P 536037

**ON-SITE SEWAGE DISPOSAL SYSTEM
 HOWARD COUNTY HEALTH DEPARTMENT
 BUREAU OF ENVIRONMENTAL HEALTH**

SUBDIVISION: Preserve at Clarksville LOT NUMBER: 20

ADDRESS: 6259 Heather Glen Way PROPERTY OWNER: Dayton Oaks LLC

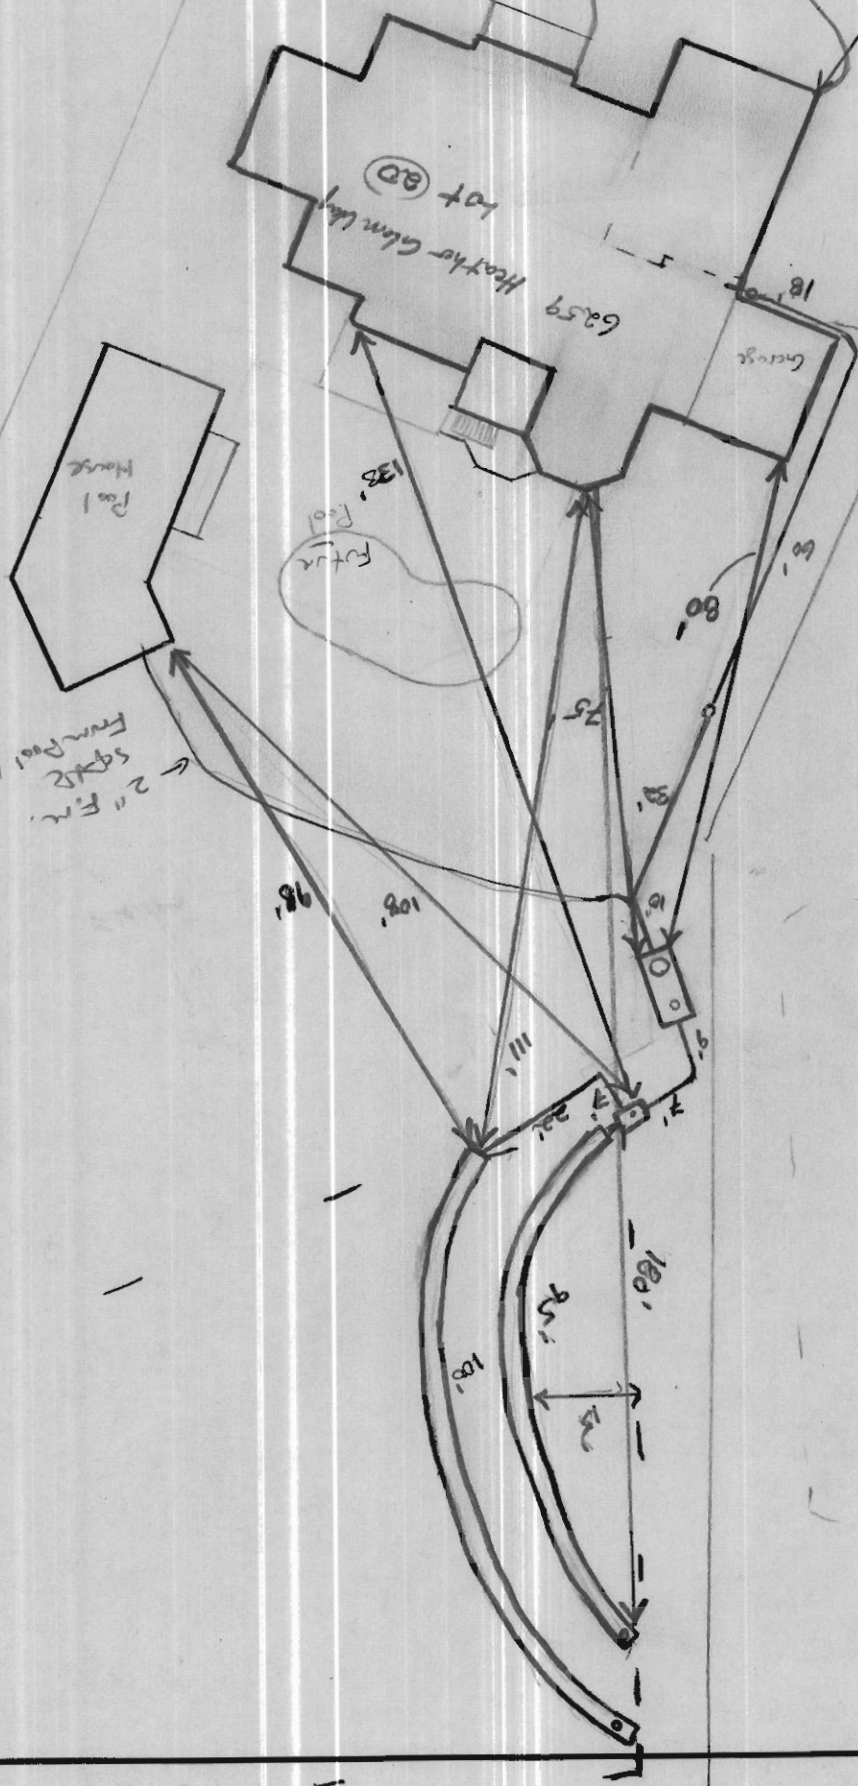
3/21/12 Elevations shot in field. Tried to make gravity system. Restricted pore hole (#97) - mudding @ 10'. Upper system held to 6' bottom. Could not make inlet @ 4' w/ gravity. Pump tank to be installed as per permit. Run a 75' trench 2'-6' and a lower 100' trench 2'-7'. (KW)

4/13/12 met onsite w/ builder and contractor, grades adjusted slightly to get help w/ fall. 5/31/12 Contractor has run plumbing down house out to S.I.T. 1/8" fall held. Told contractor should have use stone under pipe not fill. S.I.T. set. w/ Dbox. Starting top trench. Should have most of trench complete. (KW)

6/7/12 Top trench complete. 4.5' inlet held. Soil consistent w/ pore nodes. Lower trench started. Dbox leveled. (KW) 6/8/12 Trenches complete. Need to see install of plumbing from pool house to system. (KW)

7/2/12 Verbal from contractor at pool house re in e building. (KW)
